Re: Montessa Park Laboratory Facility, 3400 Los Picaros Rd. SE
Grading & Drainage Plan-Engineer's Stamp dated 10-31-05 (P17-D2)

RE: Re-Submital of Grading and Drainage Plan for Montessa Park Laboratory Facility
P17-D3.

City of Albuquerque
Montessa Park Convenience Center
Proposed Changes

TITLE : DRAINAGE PLAN
MONTESSA PARK SOLID WASTE CONVENIENCE CENTER

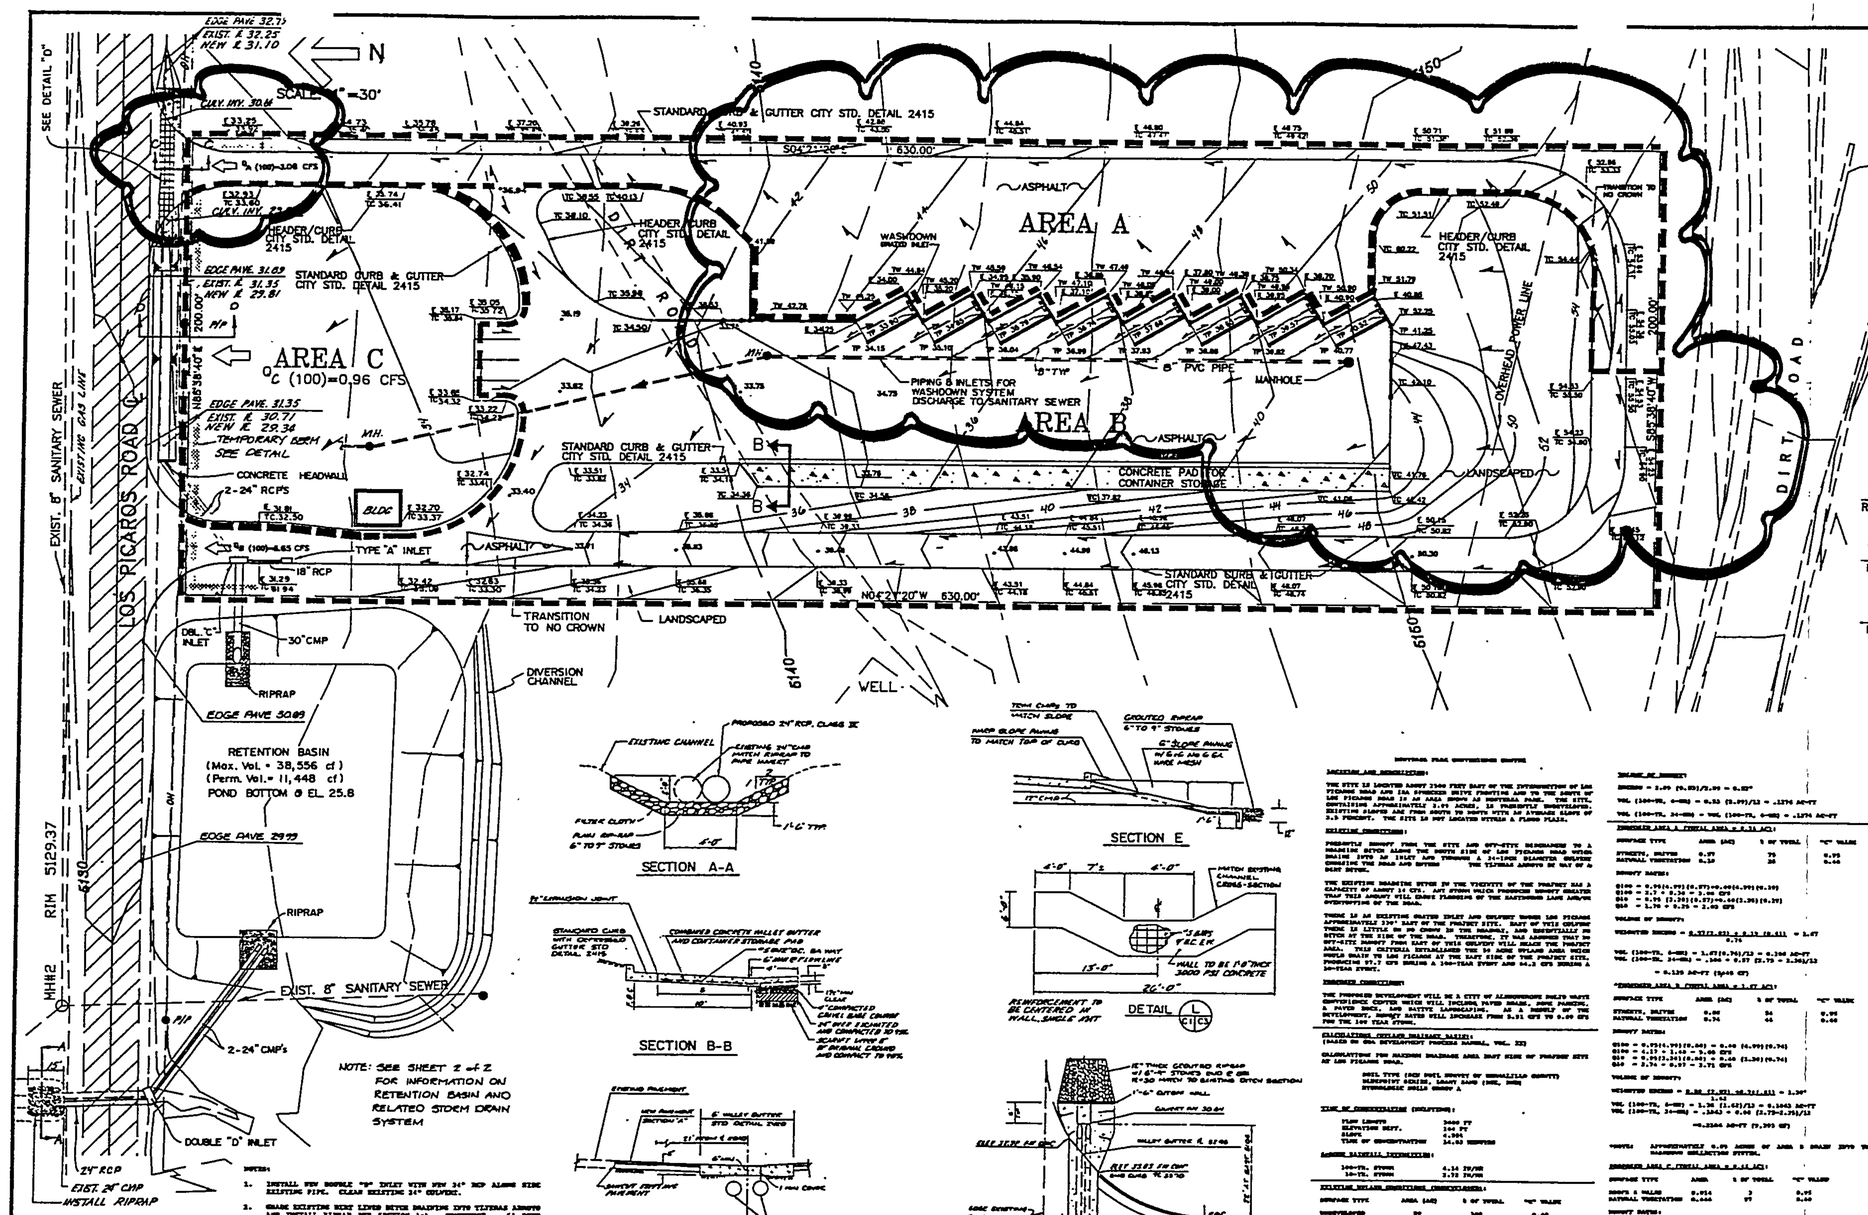
1.	Transportation	a)	No greater than 4% slope for private vehicles backing up to tipping area.
		b)	Attempt to keep truck/trailer ramp around 8% slope.
2.	Hydrology	a)	Provide updated Drainage Plan.
		b)	Provide water block at new truck/trailer entrance to prevent water onto site at this location.
3.	Utility Development	-	No comment.
4.	Zoning Administration	-	No comment.

The information provided in this letter and on the enclosed attachments is in response to your request of May 24, 1990 for a revised Drainage Plan for the Montessa Park Solid Waste Convenience Center. The Drainage Plan was updated to reflect the new site layout using four, 117 cubic yard capacity trailers in lieu of eight, 40 cubic yard capacity roll off containers. The purpose of this letter report is to supplement the original Drainage Plan dated April, 1990, as prepared by Gardner Mason and Associates. Any calculations or information not specifically revised by this letter report remains the same as shown in the Gardner Mason report. The two documents must be used in conjunction with each other.

The site revisions to accommodate the larger capacity trailers include a new truck entrance and ramp on the south end of the property, raising the elevation of the tipping floor approximately six feet, revising the profile of the private vehicle circulation road to accommodate the truck entrance and raised tipping floor, and enlarging the left hand curve at the east side exit. A reduced size copy of the original Drainage Plan, Sheet 1 of 2 has been included with the revised areas noted. The impact on the surface drainage on the site is minimal. We have not altered the original drainage concept. We have used the same drainage basins with some minor alterations in the southeast corner between Basin A and Basin B. The new truck ramp diverts some water that used to flow on the vehicle circulation road but the flow is still in Basin B and still exits the basin at the same location. The truck entrance is located at a local high spot on the existing dirt road. We have also included a valley gutter at the truck entrance, so no water will enter the site from offsite. The truck ramp adds some impervious

area to Basin B but we have also changed the asphalt area between the ramp and the last container bay back to soil, so the net change is negligible. We have attached copies of the calculations we performed to evaluate the impact of the revisions on the drainage calculations. We have concluded that there is no significant change in the drainage calculations. We have also enclosed a Revised Drainage Plan, Sheet 1A of 2 showing the new contours and site layout. All other information shown on the original plan, Sheets 1 and 2 of 2 still apply.
